SUNDRY NOTICES AND REPORTS ON WELLS
Do not use this form for proposals to drill or to re-enter an abandoned well. Use form 3160-3 (APD) for such proposals.

8. Well Name and No.
CEDAR CANYON 27 FEDERAL COM 1H

OXY USA Inc. respectfully requests approval for the following changes to the drilling plan:

CONDITIONS OF APPROVAL

Cedar Canyon 27 #1H
Eddy Co, New Mexico

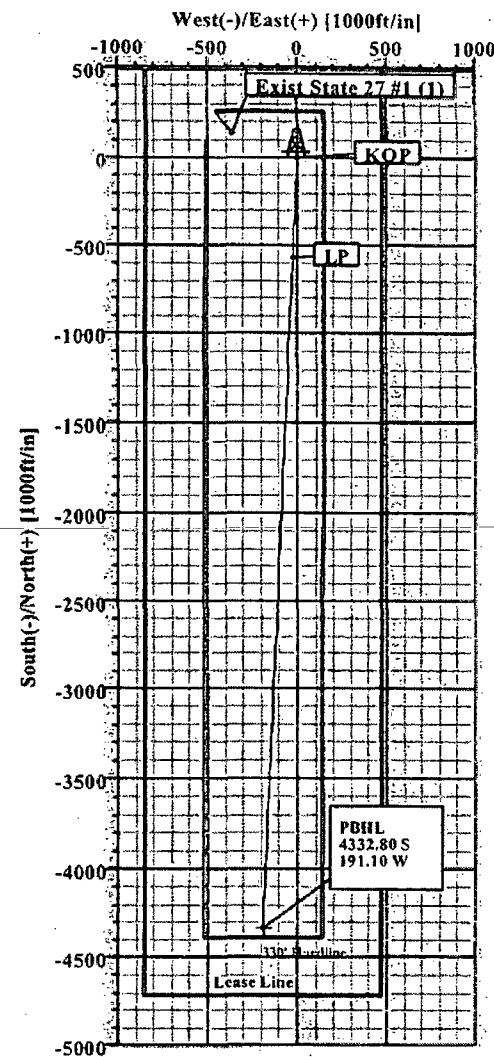
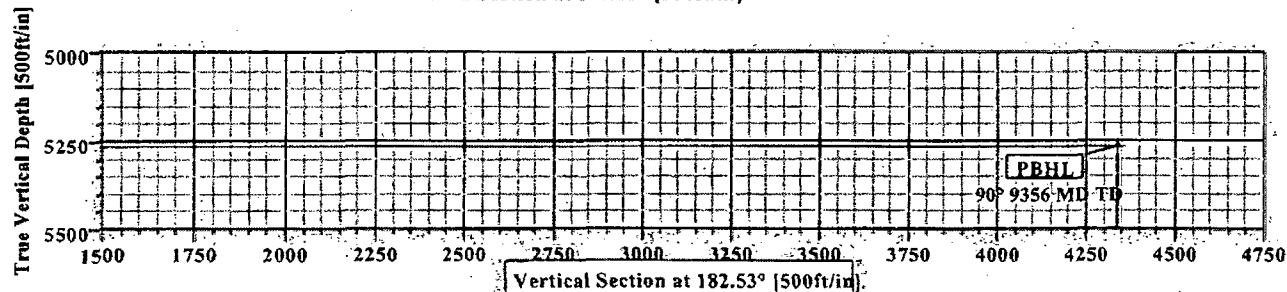
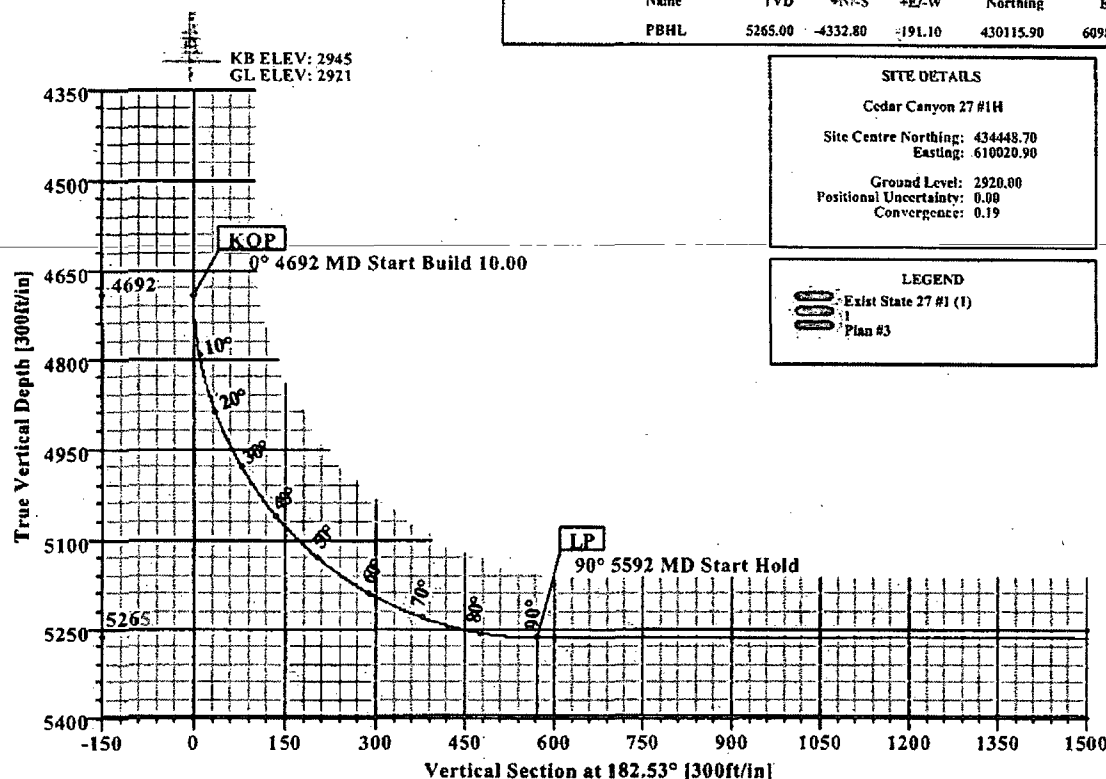
1. Directional plan modification. New target 9356'TMD 5265'TVD for the lateral section, see attached for directional plan.

1. Directional plan modification. New target TVD for the lateral section is 5265' (still in the Brushy Canyon formation.).
2. Casing design modification, to drill the well with smaller bit sizes: 14 3/4" surface hole, 10 5/8" intermediate hole and 7 7/8" production hole.
3. Cement volumes adjustment to the new depth and bit/casing sizes. Cement recipe modifications.

3. DIRECTIONAL PLAN

Please see attached directional plan

SECTION DETAILS										
Sec	MD	Inc.	Azi	TVD	+N-S	+E-W	DLog	TFace	VSec	Target
1	0.00	0.00	182.53	0.00	0.00	0.00	0.00	0.00	0.00	
2	4692.04	0.00	182.53	4692.04	0.00	0.00	0.00	0.00	0.00	
3	5592.04	90.00	182.53	5265.00	-572.40	-25.25	10.00	182.53	572.96	
4	9356.10	90.00	182.53	5265.00	-4332.80	-191.10	0.00	0.00	4337.01	PBHL
